Seismic Walkdown Checklist (SWC)

Equipment ID No. Q1R43E001A Equip. Class[1] 20

Equipment Description SEQUENCER B1F

Location: Bldg. AUXILIARY Floor El. 139 Room, Area 335

F1 -101

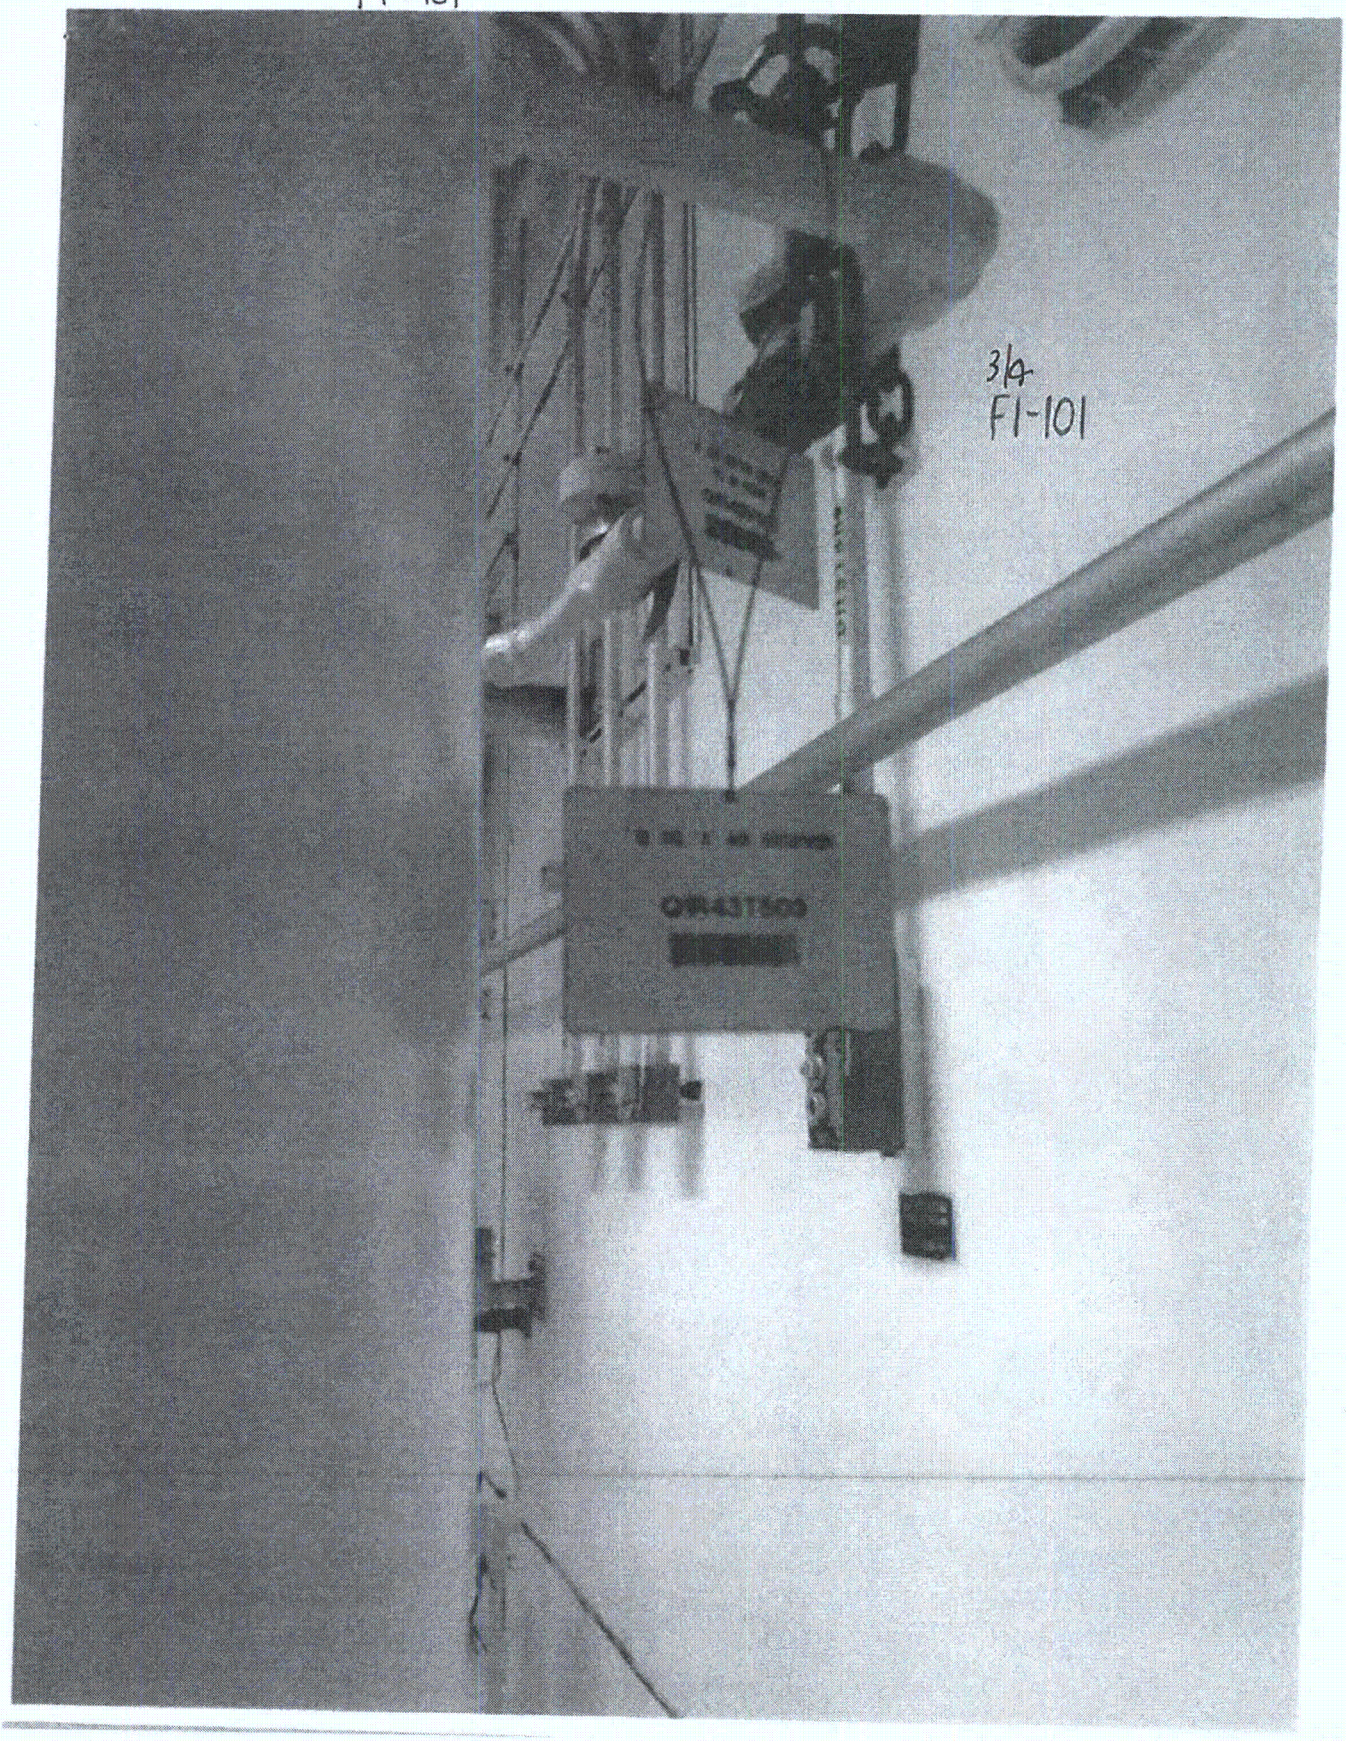
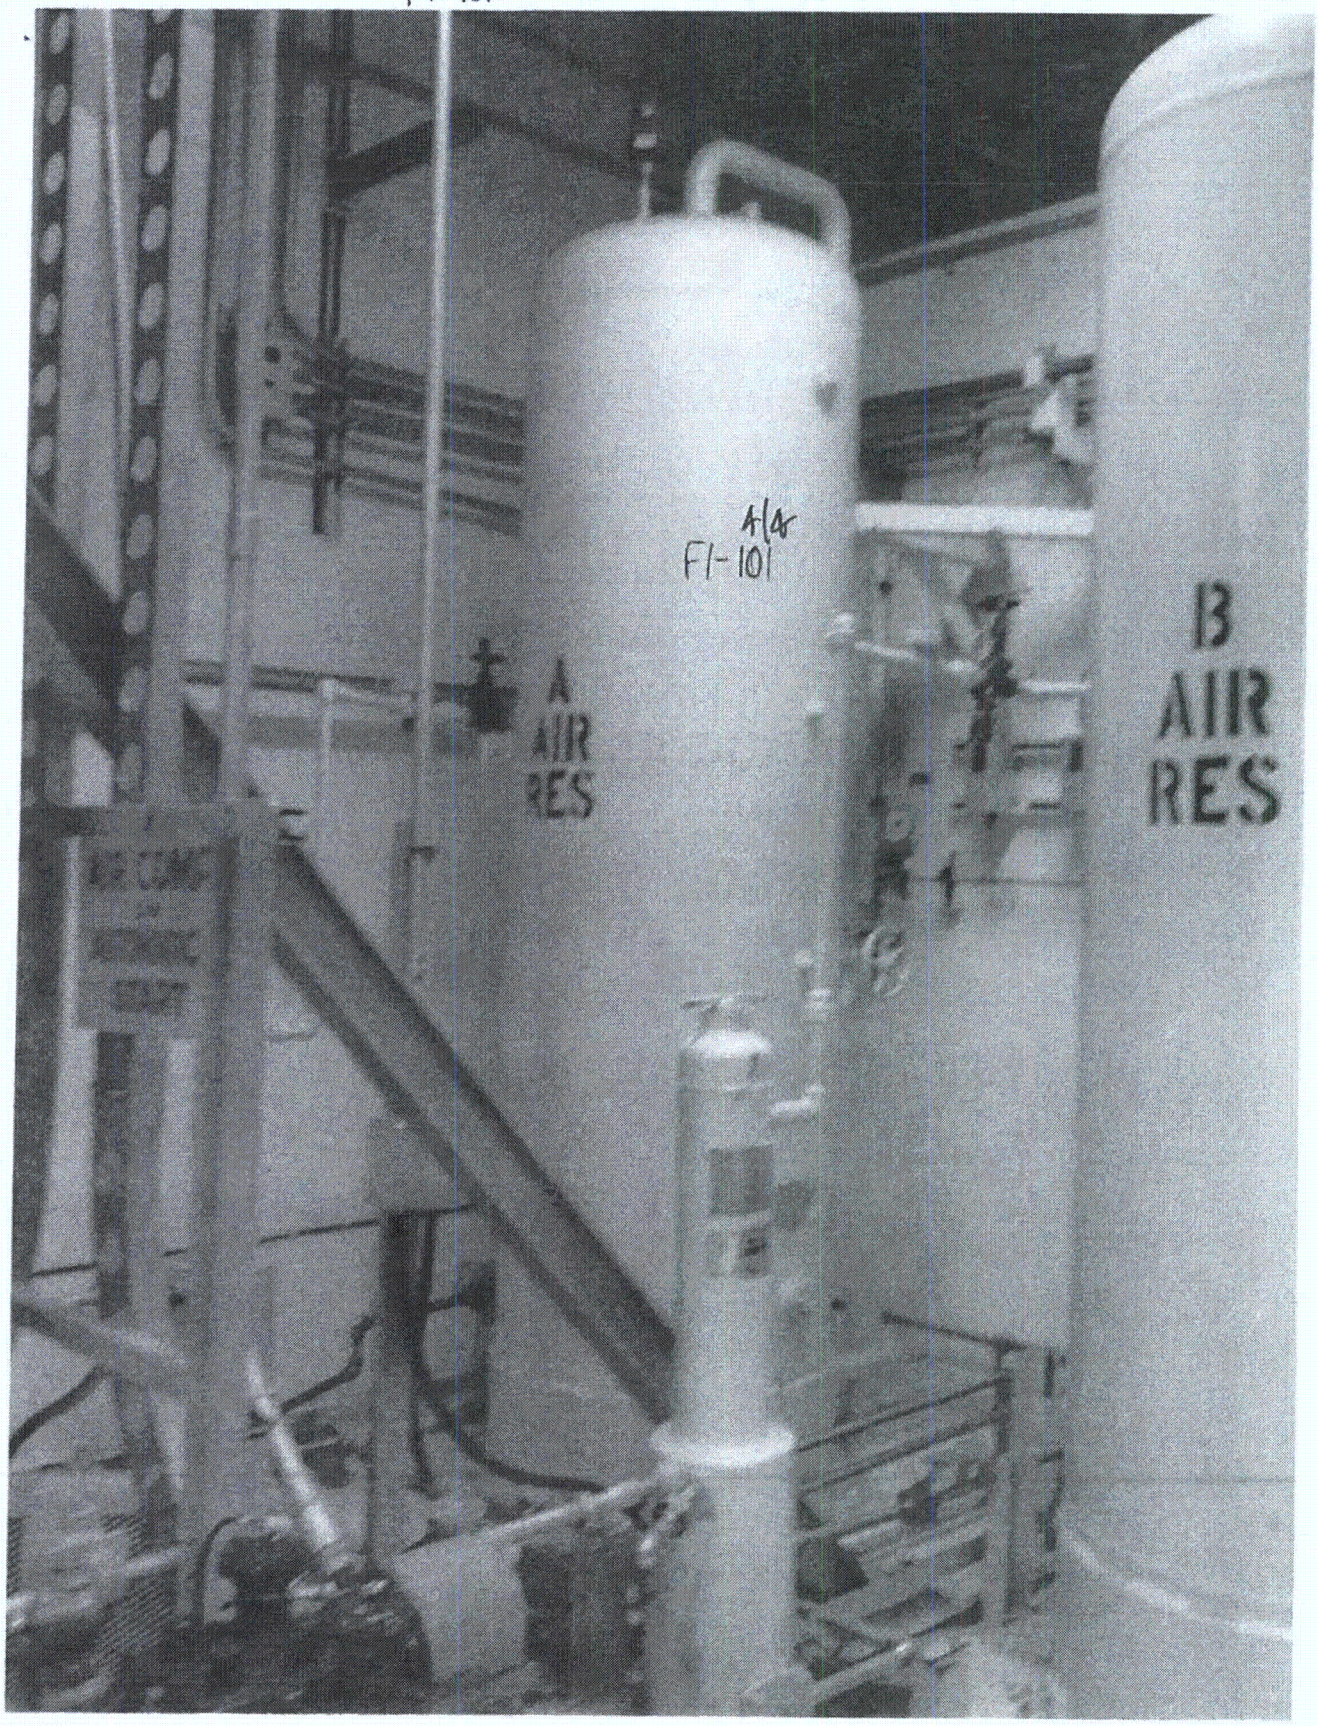
7. Are soft targets free from impact by nearby equipment or structures? Y☒ N☐ U☐ N/A☐
   Small gap was noted between tank and cantilevered unistrut. This was previously noted in A-46 walkdowns and determined to be acceptable.

FI-103

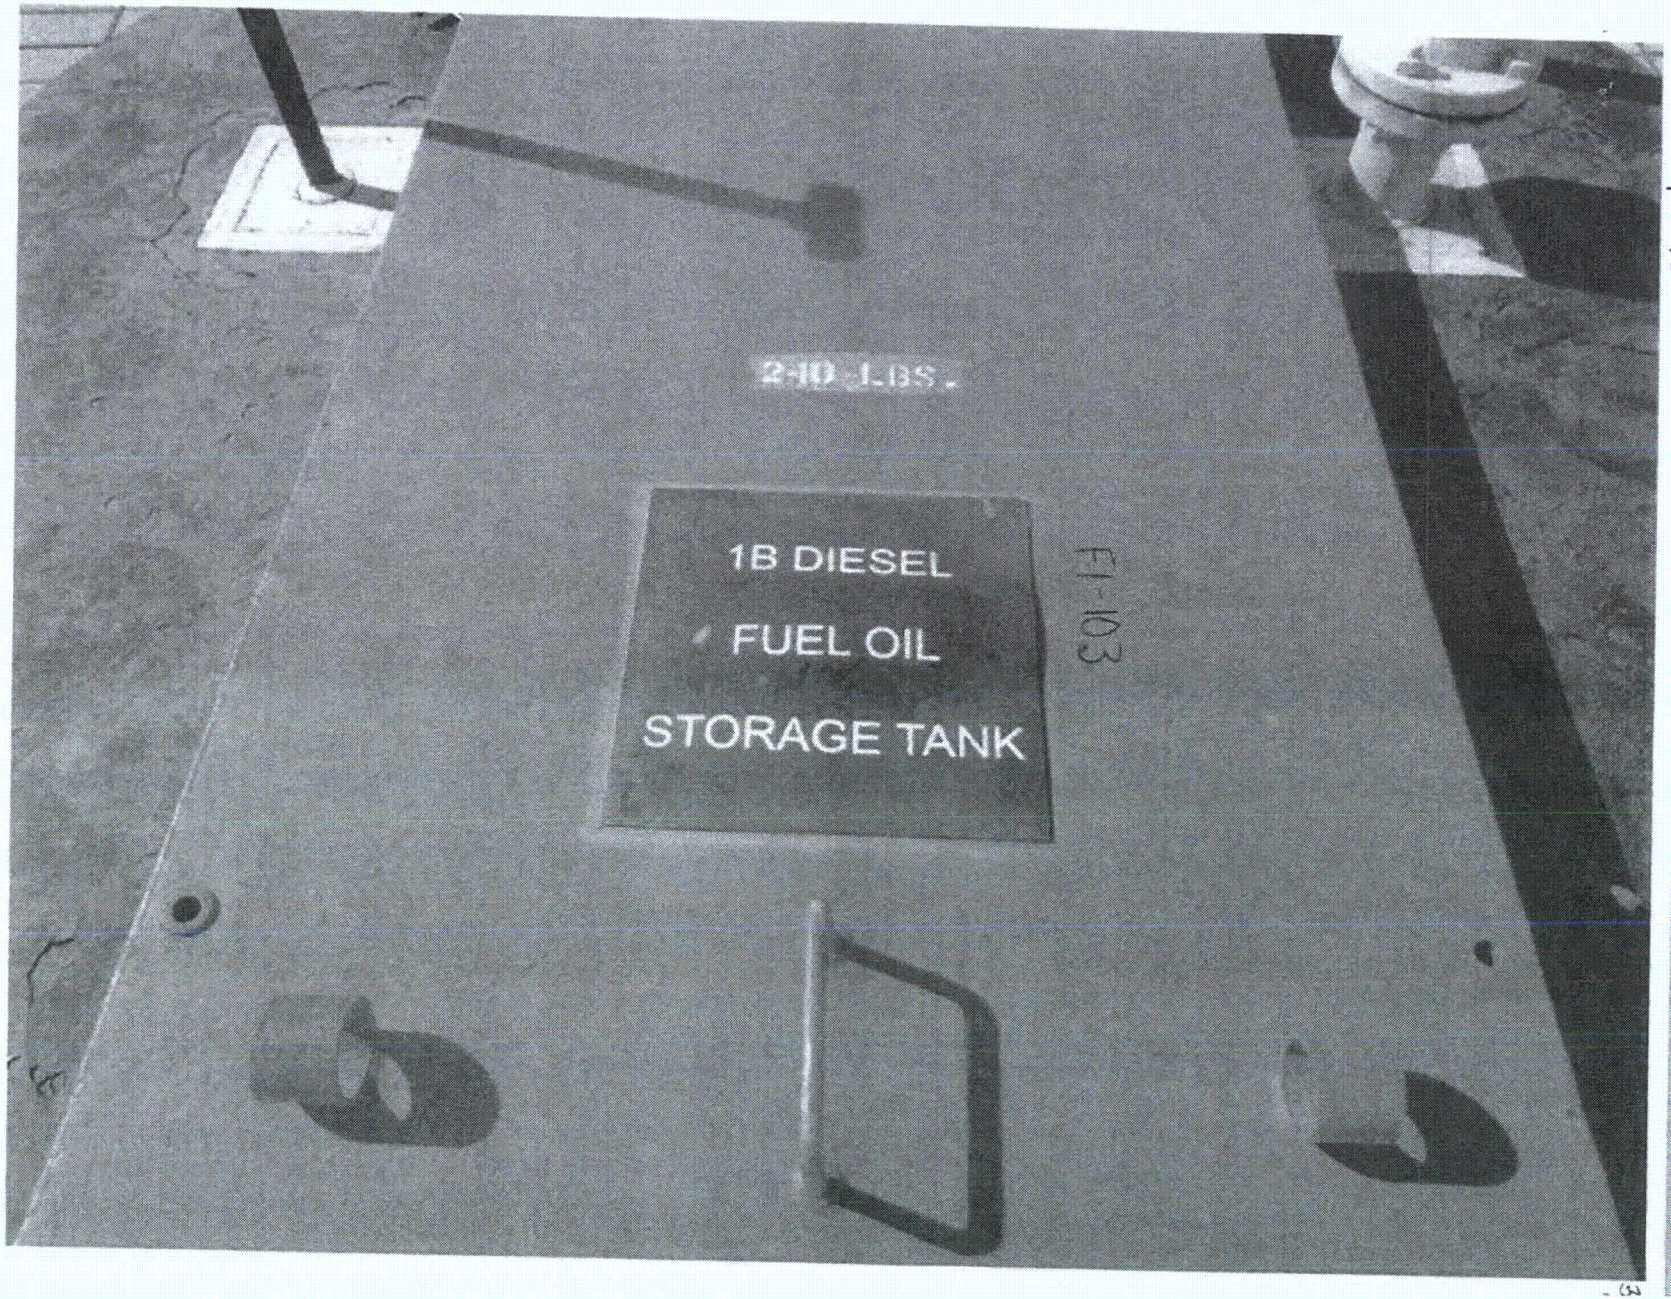
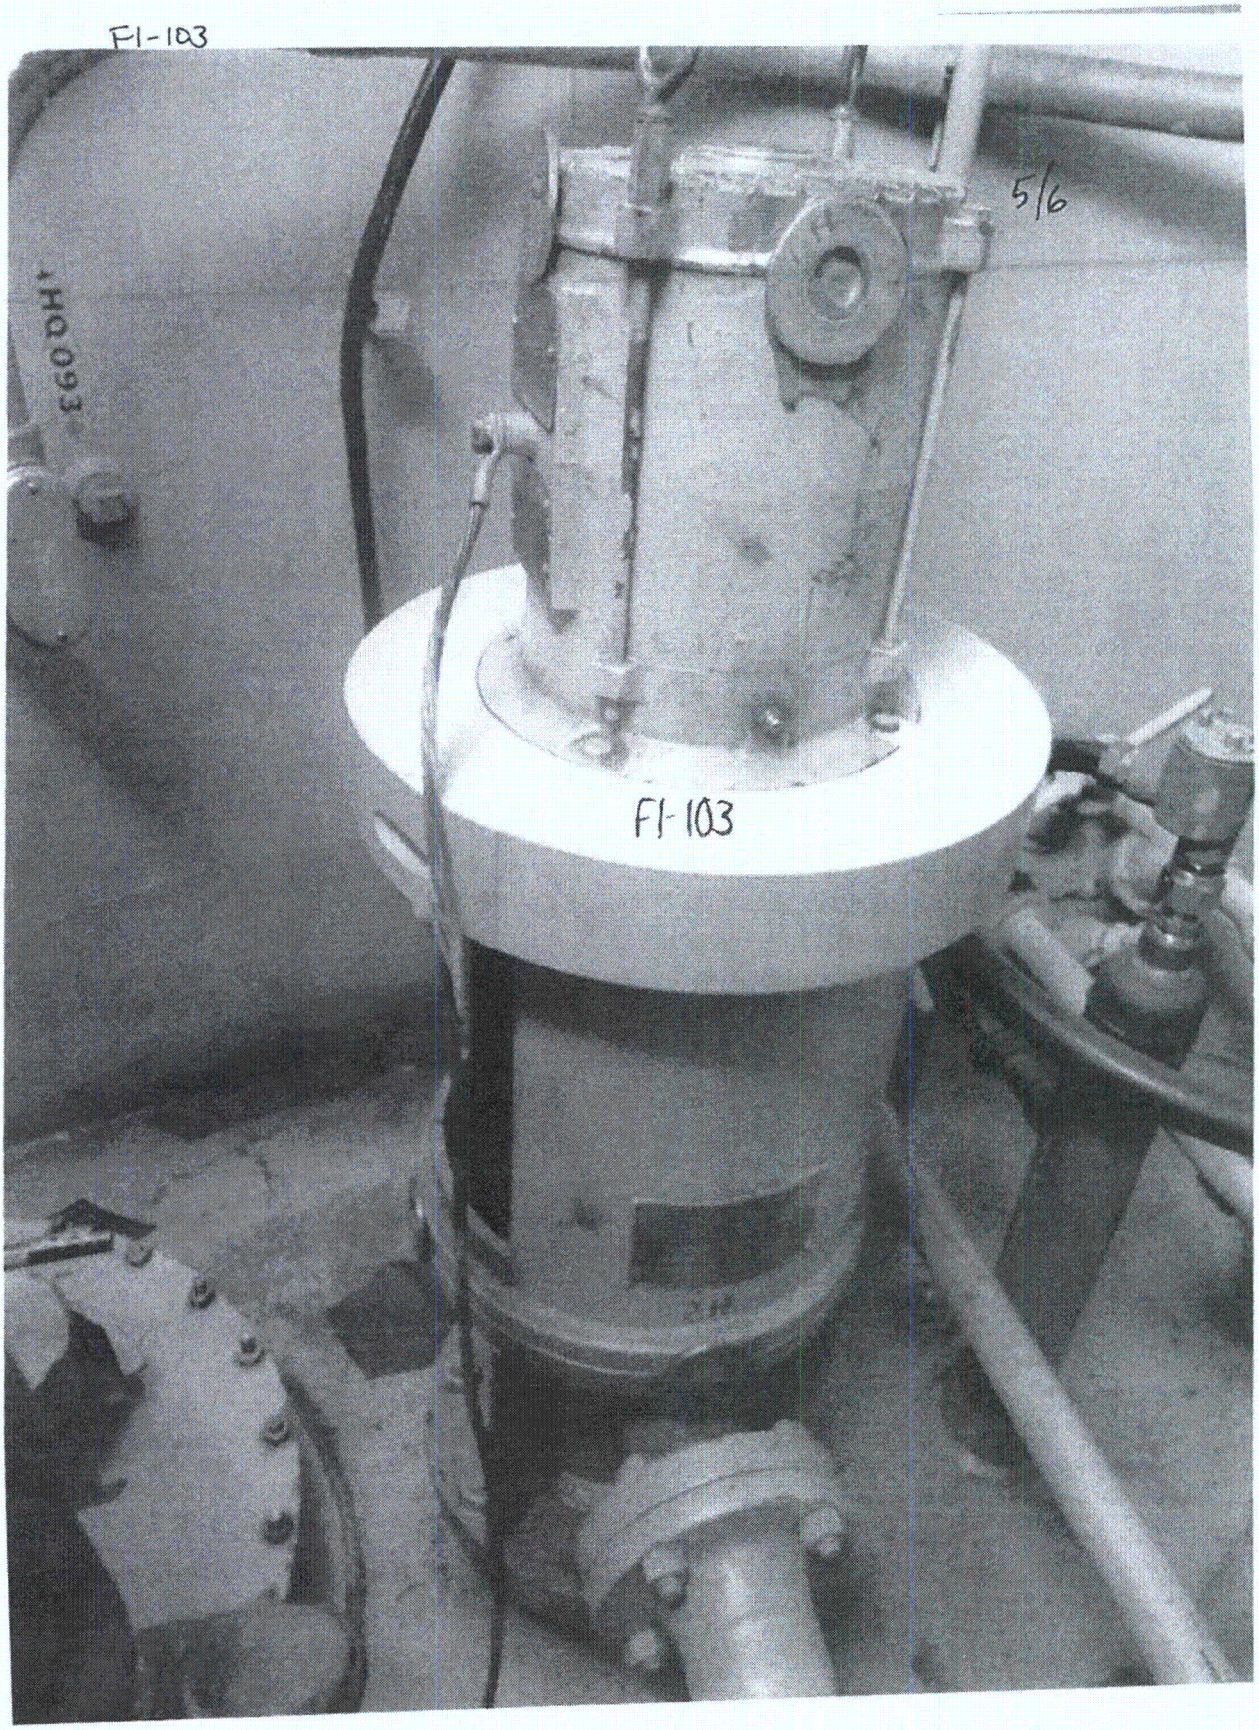
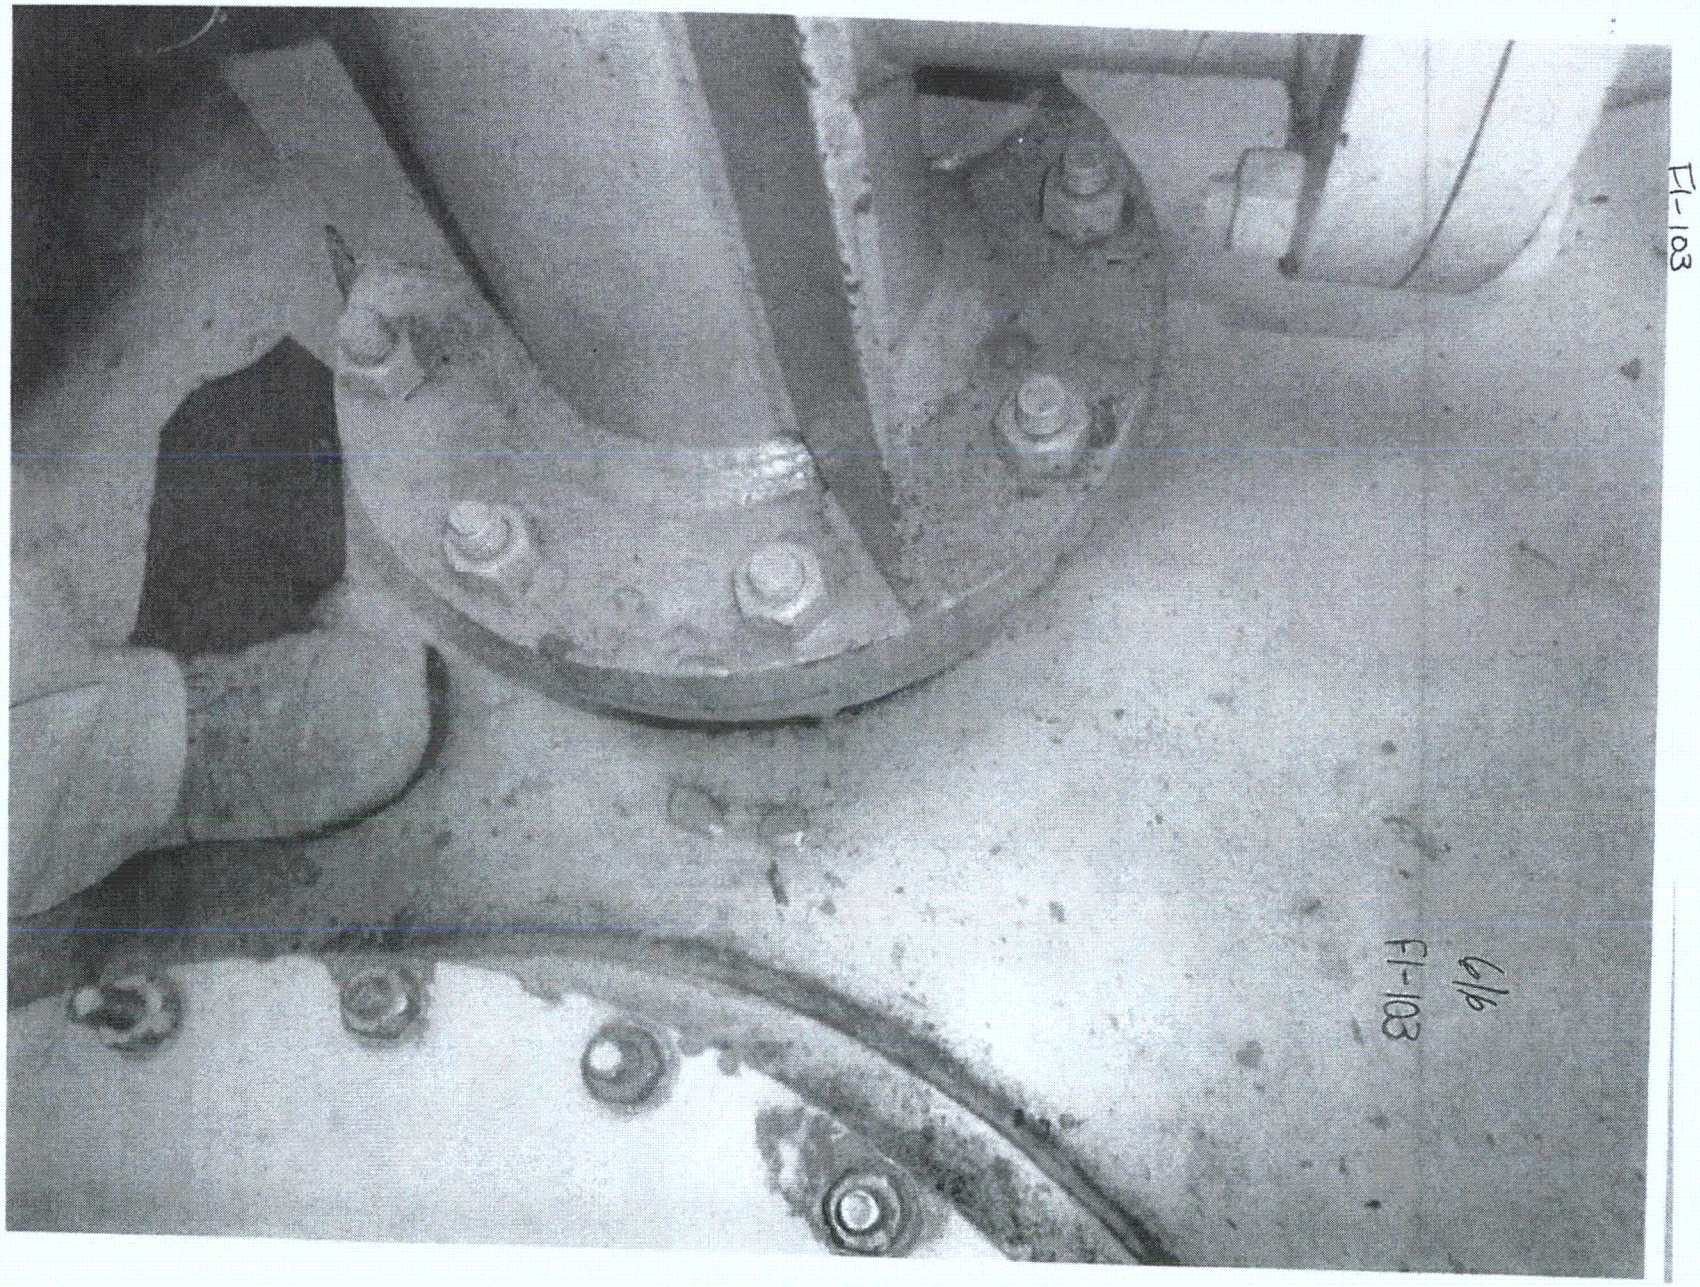
Mass added to pump to attenuate vibrations per MDC S98053790I and the effect on the pump/motor is evaluated ~~for~~ in S98053790IC005.
